**Re: Response to Preliminary Geologic/Seismic Hazard Review and
Supplemental Geologic Investigation
Proposed Senior Housing Facility
4200 Dove Hill Road
San Jose, California
Langan Project No.: 770619902**

This letter presents our response to review comments by the San Jose Department of Public Works (SJDPW) dated 25 September 2015 regarding our Geotechnical Investigation and Geologic Hazard Evaluation report dated 30 June 2015 for the proposed senior Housing Facility project at 4200 Dove Hill Road in San Jose, California. SJDPW had several comments (designated 1 through 13 in their review letter) regarding geologic/seismic hazards evaluation and mitigation at the site; a copy of the review letter is included in Appendix D. The project will consist of two new buildings, designated as Buildings A and B; both buildings are proposed to be four stories above a podium level as shown on Figure 1.

DOVE HILL ASSISTED LIVING COMMUNITY
4200 DOVE HILL ROAD
 San Jose, California
SLOPE STABILITY ANALYSIS
IDEALIZED SUBSURFACE PROFILES
1-1', 2-2', 3-3', AND 4-4'
POST GRADING

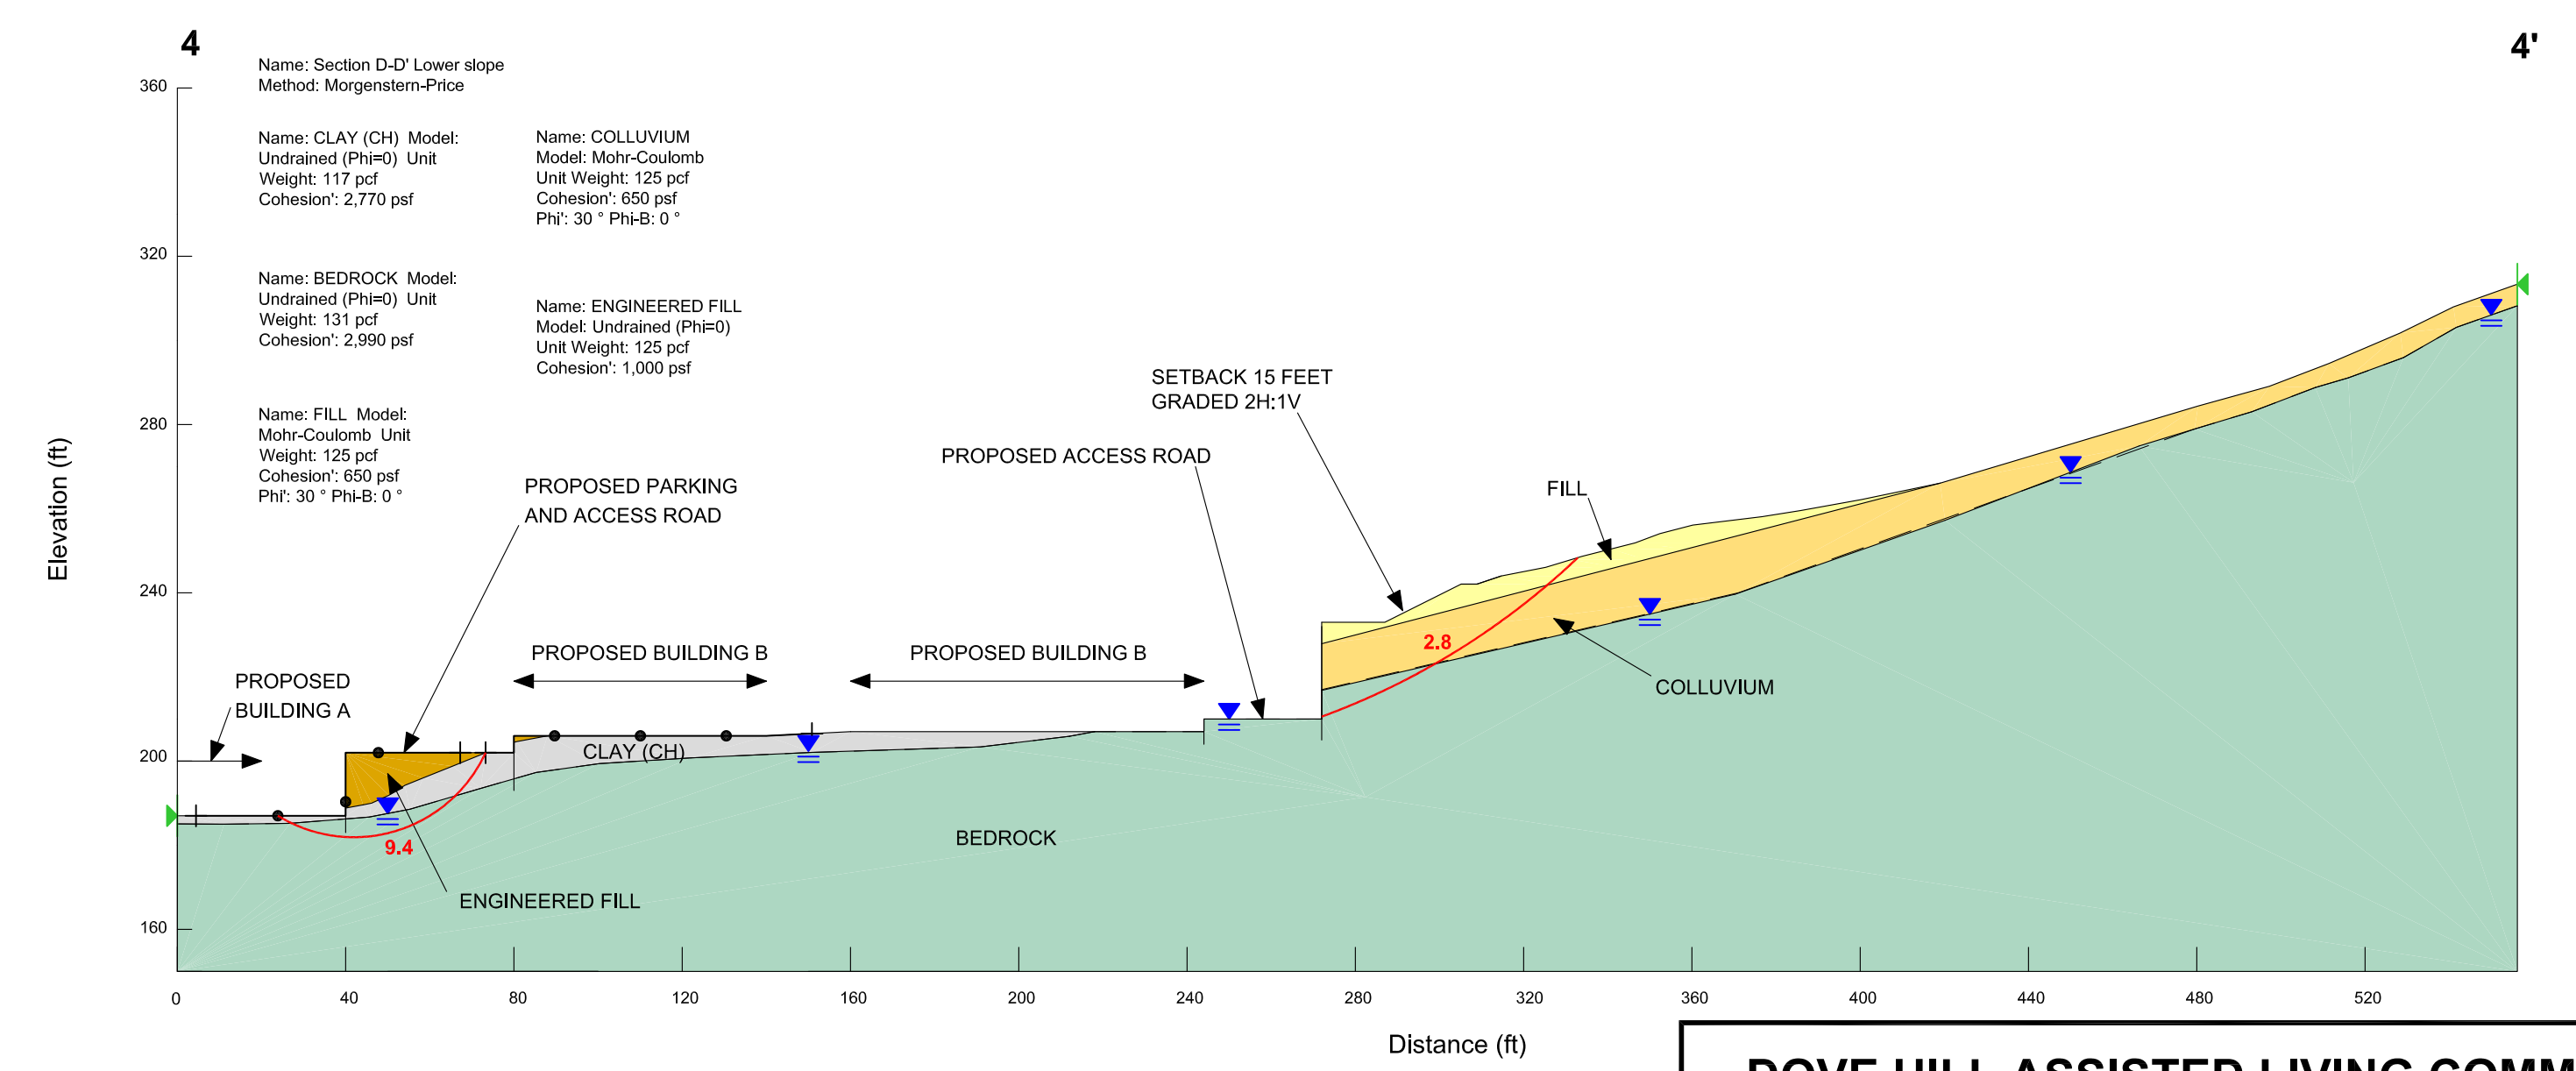
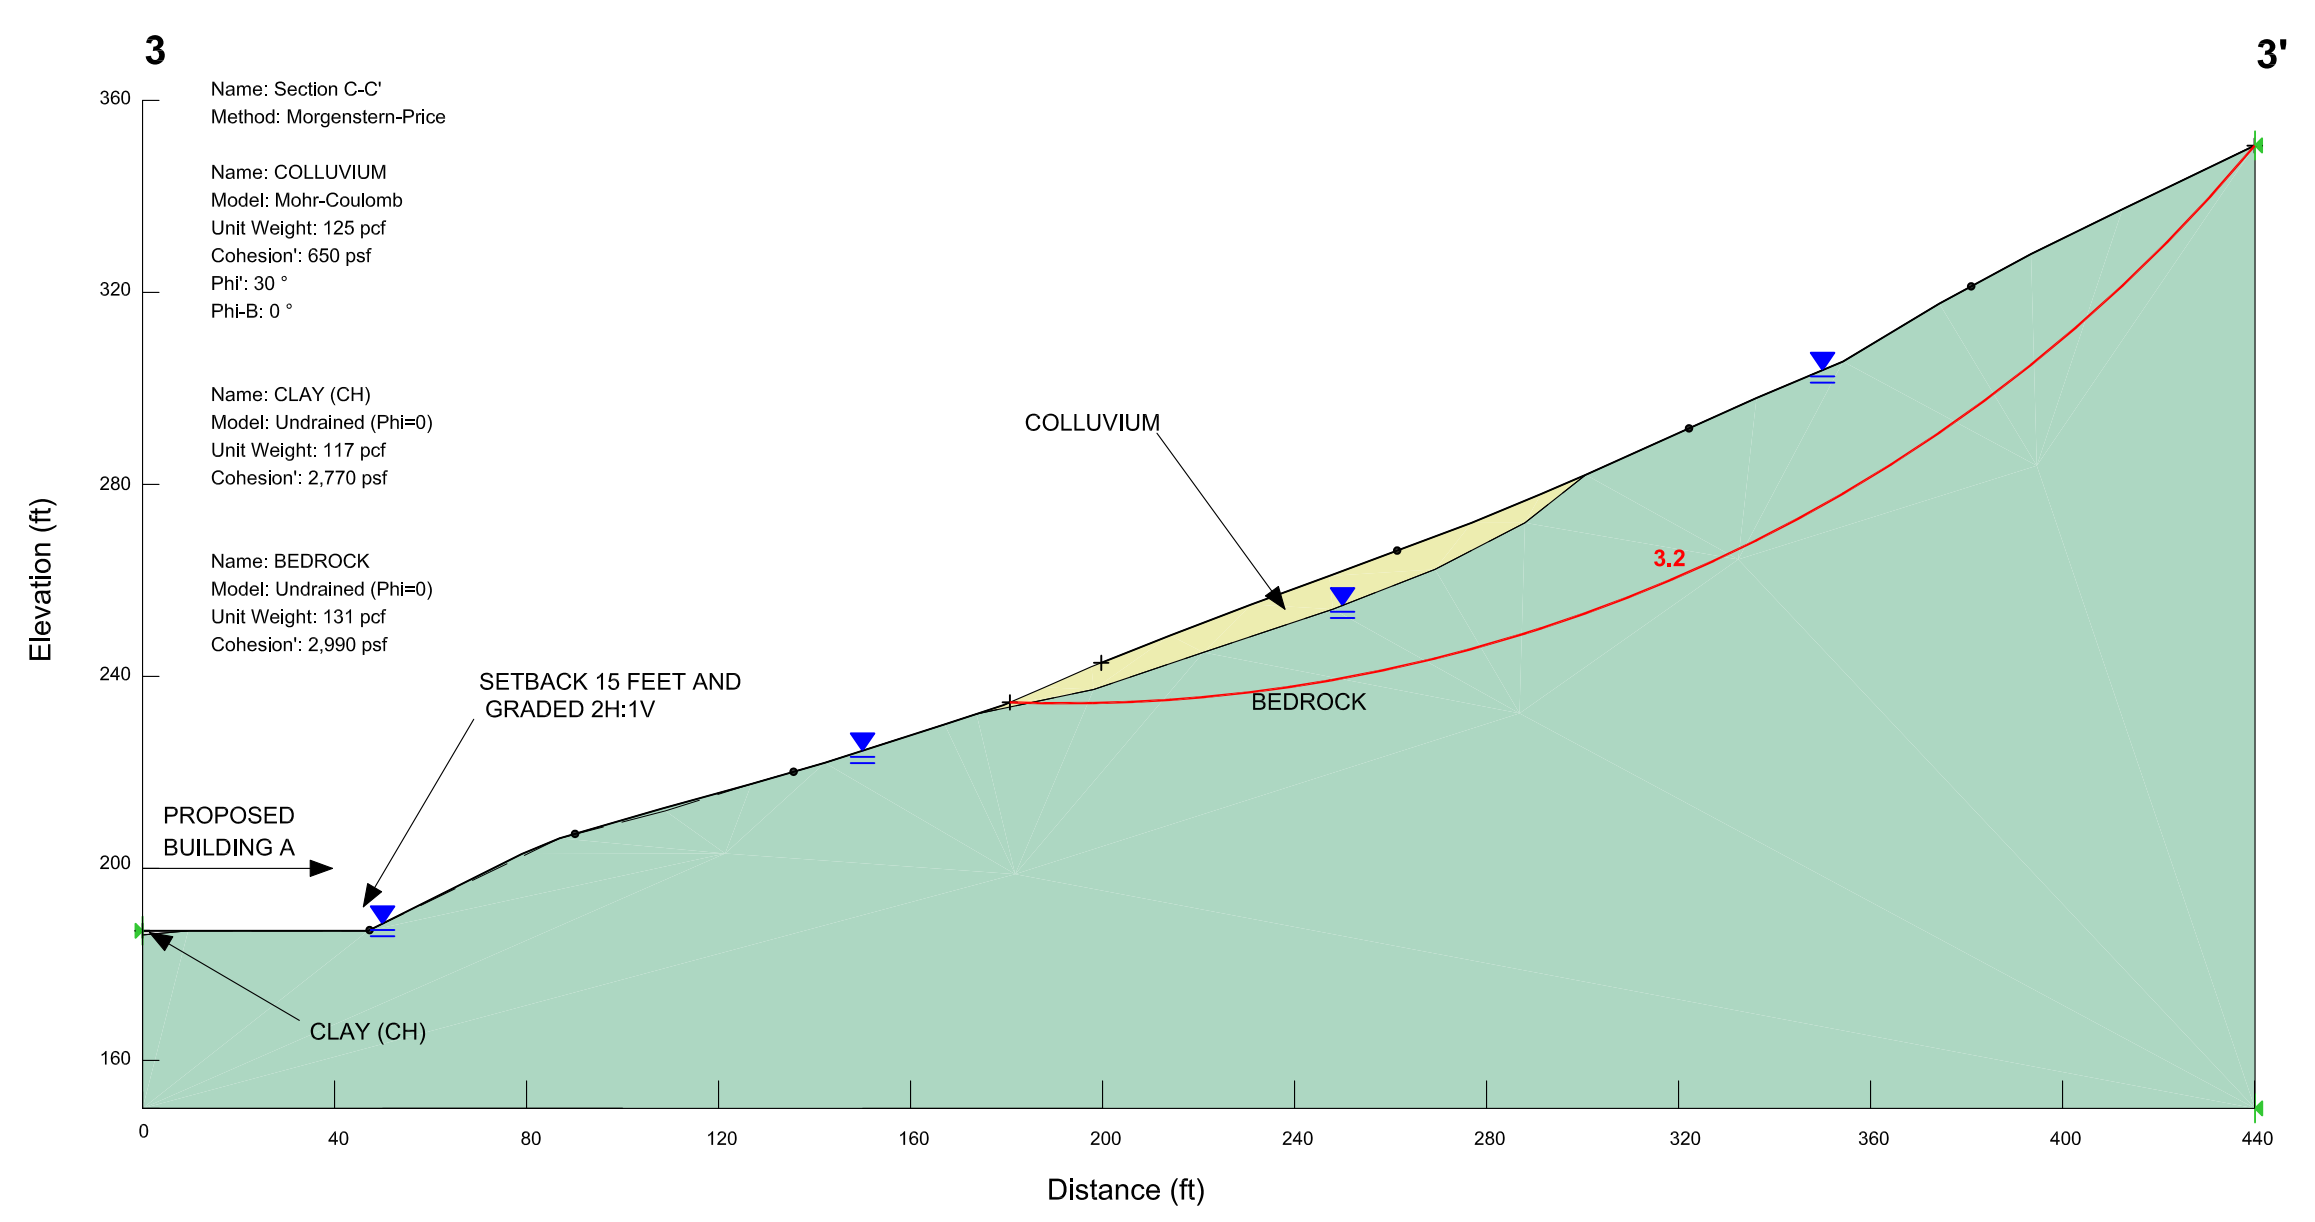
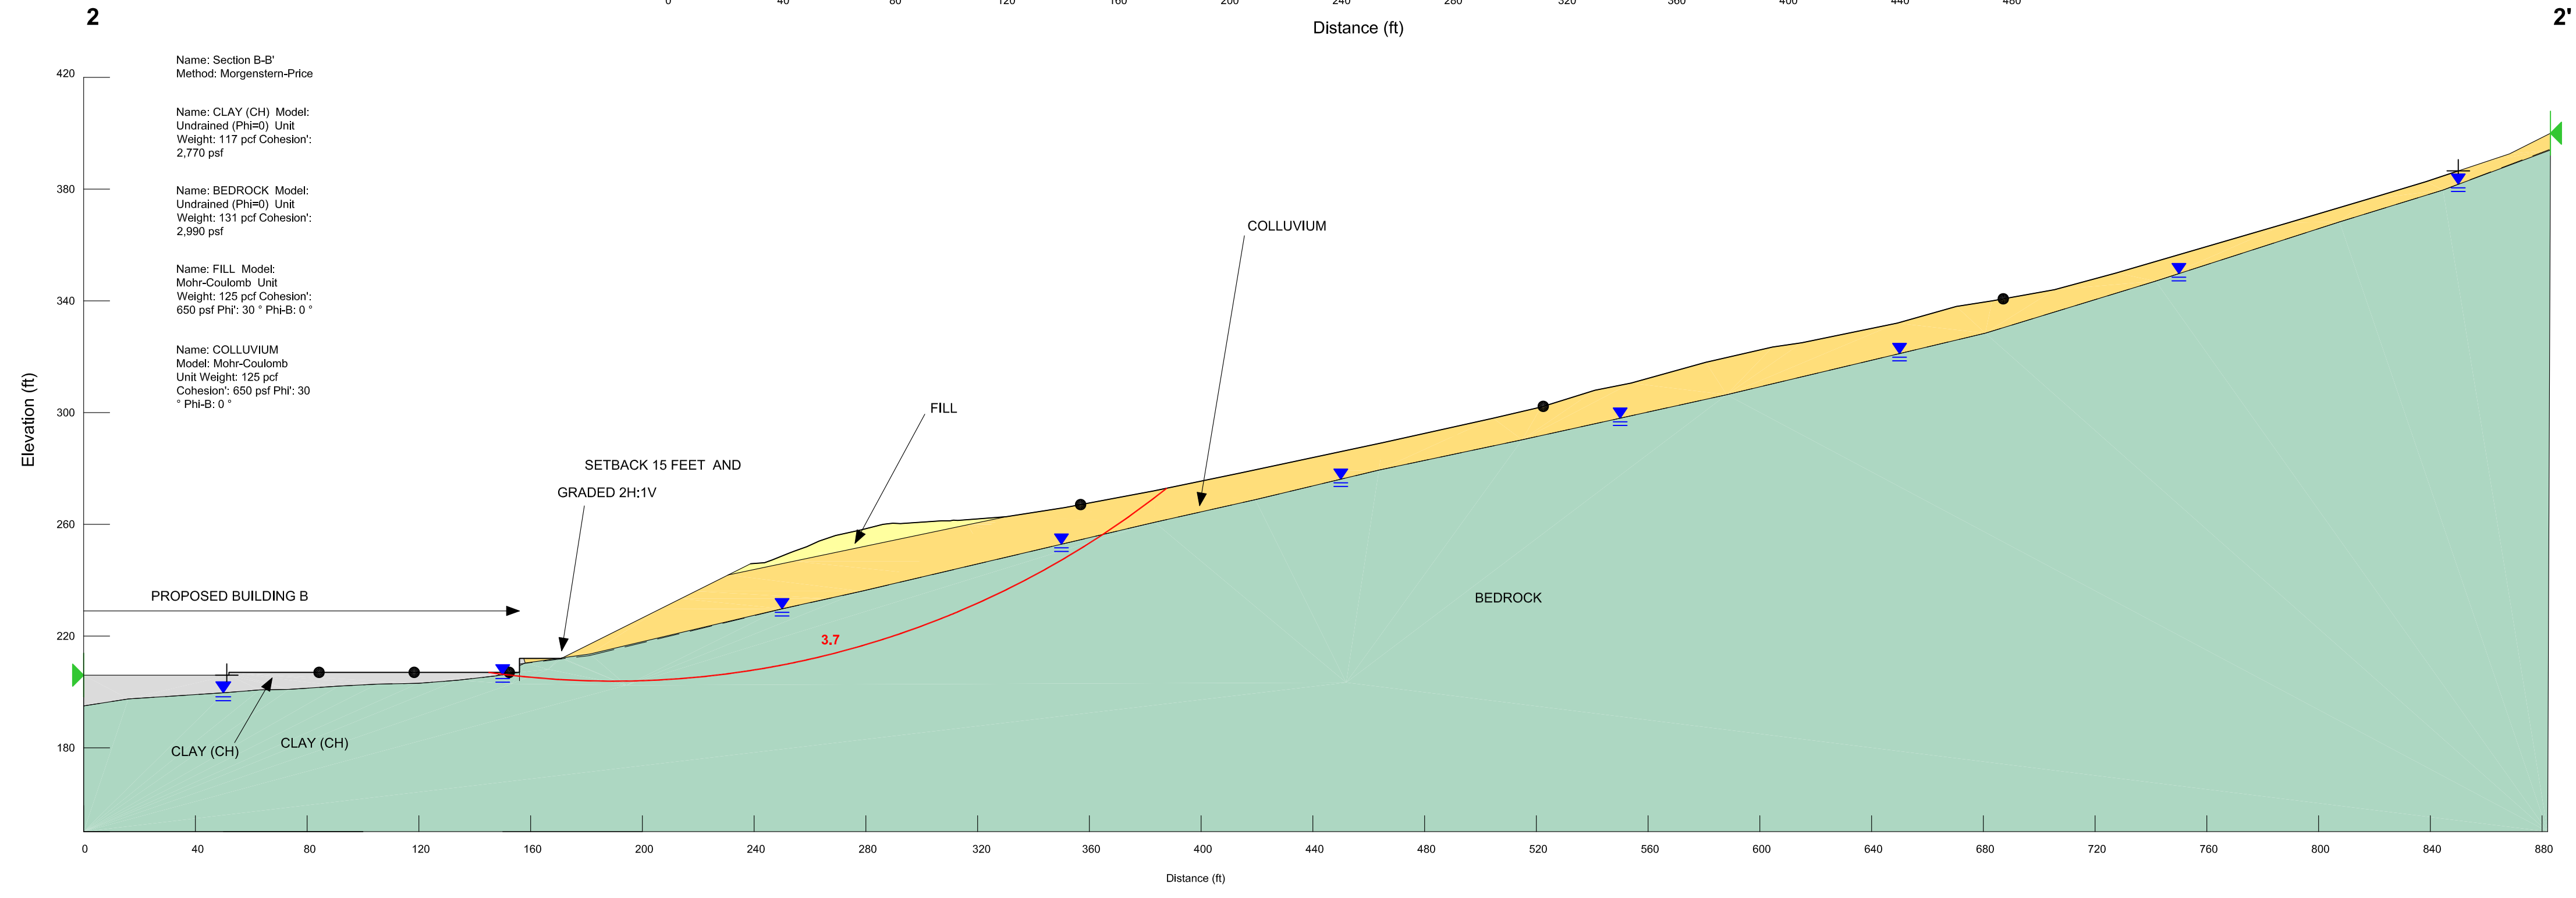
SJDPW stated that large cut and fill slopes are not shown on the grading plan and that the proposed grades do not appear to have been incorporated into our slope stability analysis models. They requested that proposed cut/fill slopes and finished grades be shown on the grading plan and incorporated into the slope stability analyses and analyzed for static and seismic slope stability.

Current plans are to grade the proposed building pads and outlying access roads and sidewalks. Grading will consist of cut and fill to level out areas for the proposed buildings. If the development is graded as proposed including removal and regrading of the existing landslide south of building B, the results of our analyses indicate an adequate safety factor. The results

of our slope stability analyses and seismic slope displacements, which include the proposed grading, are summarized in Table 3. The location of the critical slope failure surfaces for each of the profiles evaluated are provided on Figure 5.

The grading plans have been updated and are presented on the figures presented in Appendix C. In our initial evaluation we modeled the slopes under the existing and post-grading conditions both statically and seismically; however, since the engineering properties and grades have changed, we reassessed the slope analysis as suggested in previous comments. The location of the critical slope failure surfaces for each of the profiles evaluated are provided on Figure 5.
